Subject: RE: CM/52/21/DOC

Further to your call on Friday, the condition requiring boundary treatments is in respect to the western and southern boundaries highlighted yellow in the plan below.

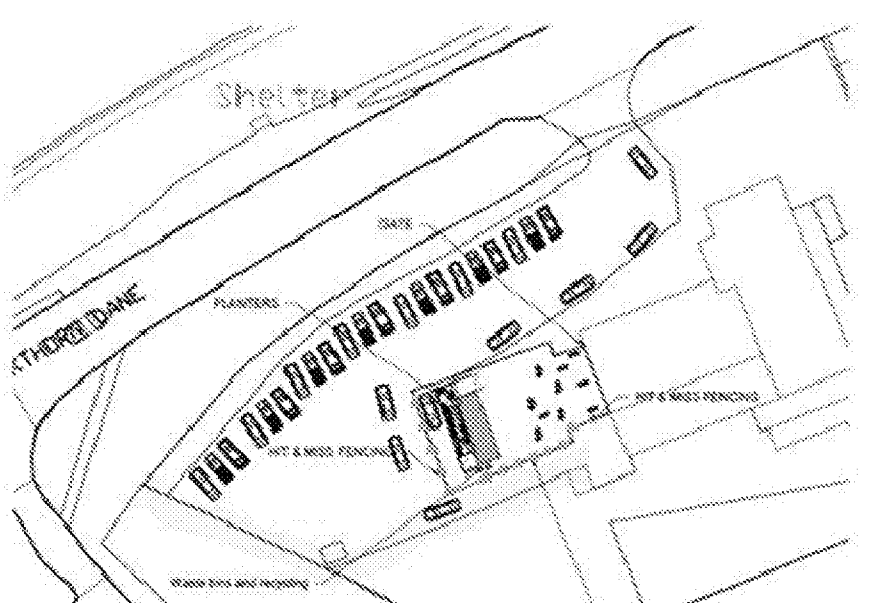
Your application shows the fencing already erected by the landowner along the western boundary which is fine. You then show a line of laurel plants along the southern boundary. There needs to be a similar style close-boarded fence along this line but you could retain the laurel plants in front of it if you wish.

Therefore what we require is an annotated block plan (suggest you annotate the approved one from the application) which indicates existing fencing along the highlighted western boundary and indicates new fencing along the highlighted southern boundary. You will need to highlight the respective boundaries like I have done (albeit more accurately) and add text to say what each of the two boundaries is. Then we will need a fencing specification for the southern boundary so we know exactly what we are approving.
